**PATTON MARINE SURVEYORS
And CONSULTANTS, INC.
P.O. Box 331884
Miami, FL 33233-1884, USA**

**December 20, 2023
File No.: 13560-24
Page 1 of 17**

**RE: "ARIADNE", 1979,
124' Breaux Bay Craft Motor Yacht**

RECOMMENDATIONS

Exposed main Engine exhaust Hot spots

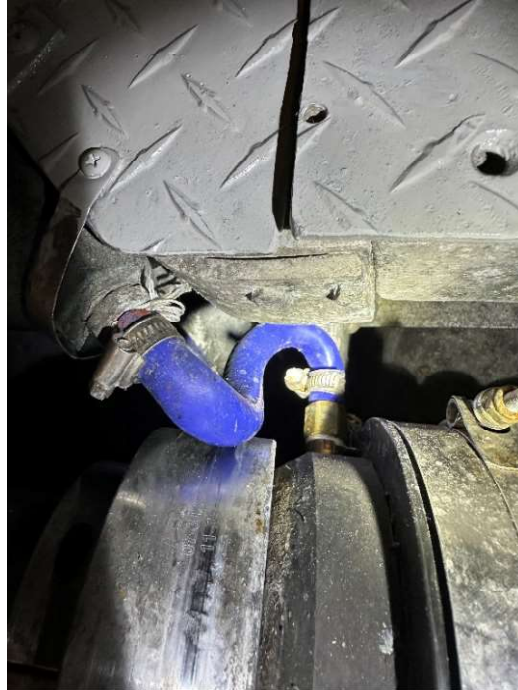
1. ★The starboard navigation light is burnt out and needs to be replaced.
2. ★ Swing the compass and provide a deviation card.
3. ★The post flybridge seat hatch is labeled as the location of the Immersion suite and rocket line throwers, they are actually located in the seating storage further aft around the jacuzzi, Correct the marker location.
4. ★The chain locker bilge high water alarm is not operational. Rectify.
5. ★The bellows insulation for the four (4) main engines is damaged and misaligned. During the sea trial recorded temperatures of 400 °f were recorded. The insulation is to be replaced for safety of crew and the machinery space.
